**Re: Road Improvements on Portions of Del Mar, Madrone, and San Ramon  
Avenues in the Seal Cove/Moss Beach Area – Project Update**

**SEAL COVE ROAD IMPROVEMENTS ON  
 DEL MAR AVENUE, MADRON AVENUE AND SAN RAMON AVENUE  
 TYPICAL SECTION**

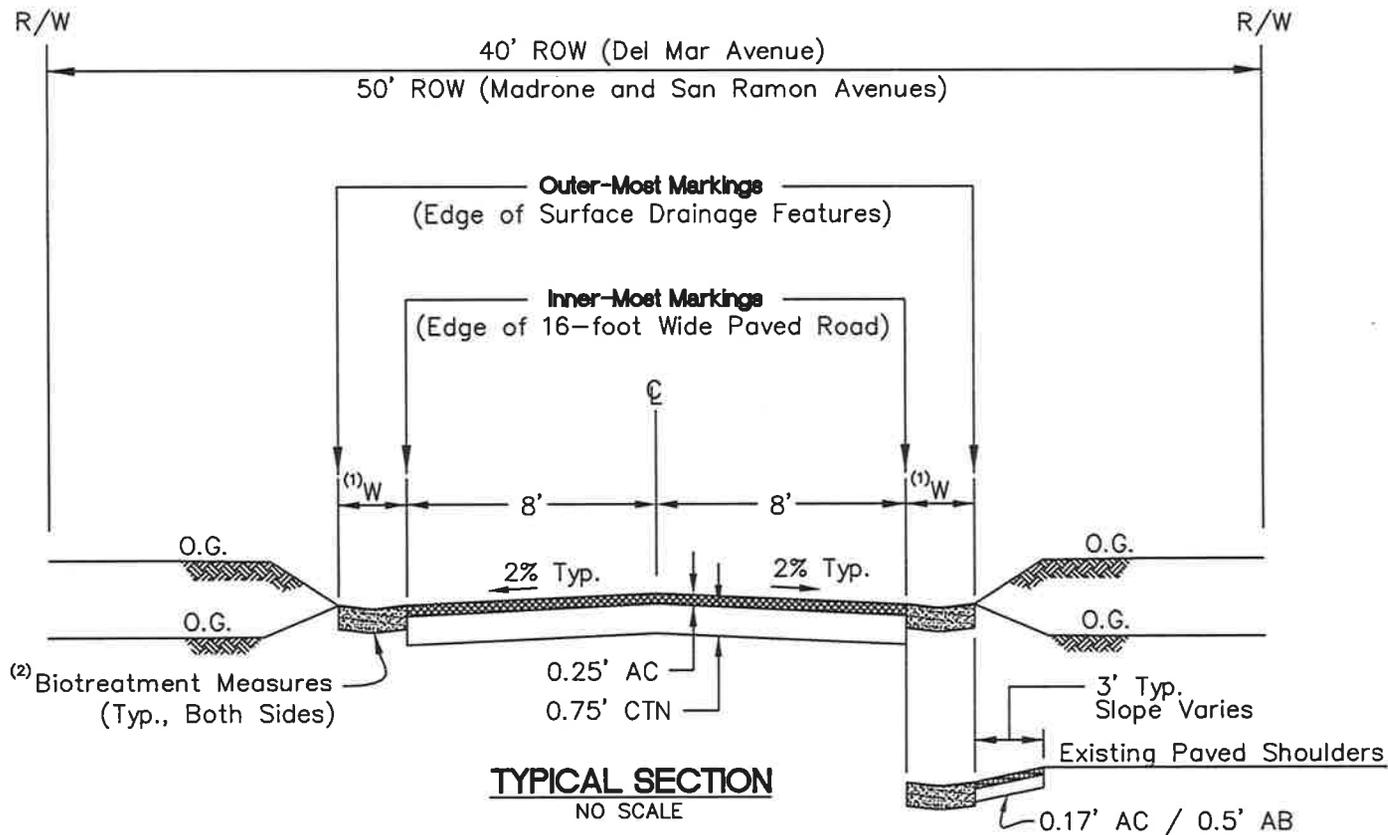
**Request for Field Markings**

**Request Consideration of Reduced Swale Sizes**

There was a request that the proposed road improvements be delineated in the field. The Department placed field markings on the above-mentioned streets during the week of April 7, 2014. As has been communicated previously, the proposed asphalt road surface is to be 16-foot wide centered within the public right-of-way with surface drainage features on both sides of each road. The inner-most markings placed in the field delineate the outside limits of the 16-foot wide asphalt road surface, which also marks the inner limits of the surface drainage features (biotreatment measures). The outer-most field markings delineate the outside edge of the surface drainage features. The enclosed “Typical Section” drawing depicts the road improvements within the road right of way and the locations of the field markings.

To comply with the Municipal Regional Stormwater NPDES (National Pollutant Discharge Elimination System) Permit (Order R2-2009-0074) (MRP), issued by the California Regional Water Quality Control Board, specific biotreatment measures are required to be incorporated into the project.

The surface drainage features serve as the above-mentioned biotreatment measures and consist essentially of vegetated swales of

widths varying from 3.5 to 5.6 feet with depths ranging from 0.35 to 0.6 feet along the outside edges of the roadway. A series of rock check dams are to be constructed across the swales in specific locations to retain the stormwater runoff and help facilitate stormwater treatment and infiltration. ***The widths and depths of the swales have been designed to meet the required stormwater treatment volumes for compliance with Provision C.3 Requirements of the MRP.*** As stated in our letter dated March 14, 2014, additional stormwater measures will be constructed at an alternate location (Carlos Street between Virginia and California Avenues) to comply with the stormwater requirements as accommodating all stormwater measures within the project limits was found to be infeasible due to the need for even wider swales.
